CITY OF ALBUQUERQUE

RE: Worthan Residence
7908 Shiprock Ct. NW
Lot 21 Block 7 Volcano Cliffs Sub. SAD 227
Grading and Drainage Plan
Engineers Stamp Date 5/25/18 (E10D046)

WORTHEN RESIDENCE 7908 SHIPROCK CT. NW ALBUQUERQUE, NM

GRADING AND DRAINAGE PLAN design by

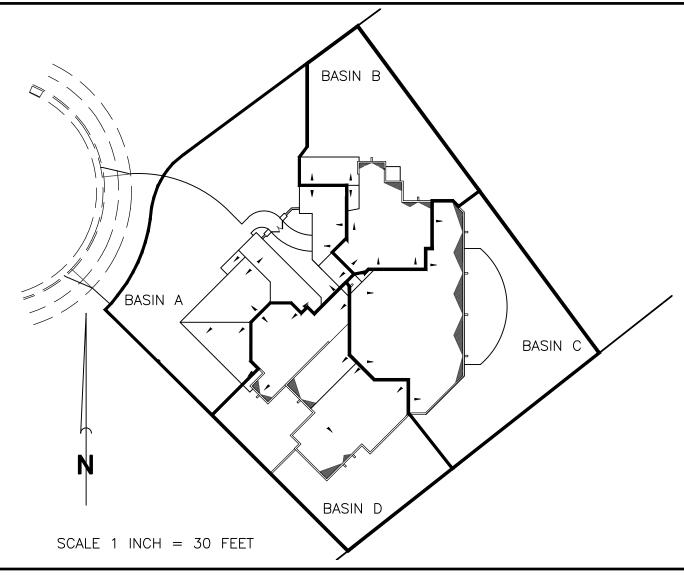
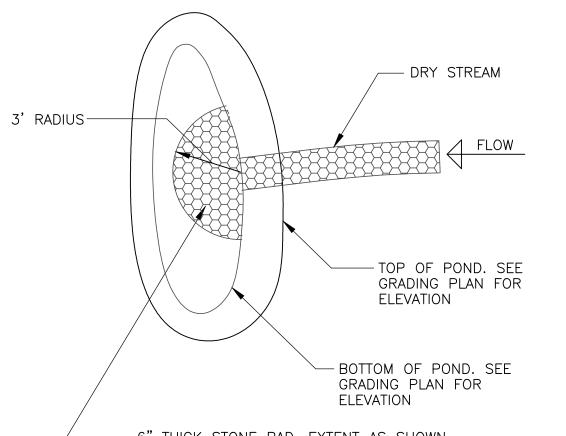
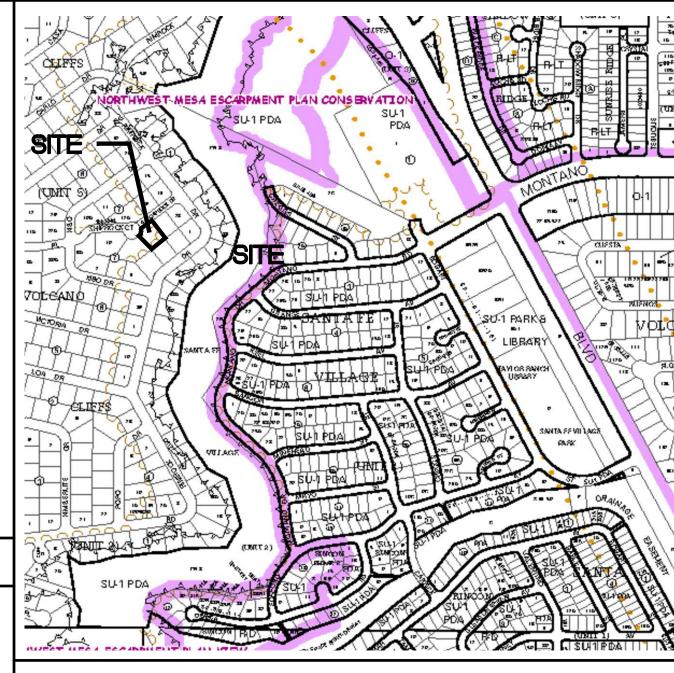
- Provide a note 10 in the SW yard wall.
- Remove the Engineers Certification block or draw an X signifying this block is omitted.
- Provide sheet 13 of the architectural plans for review.
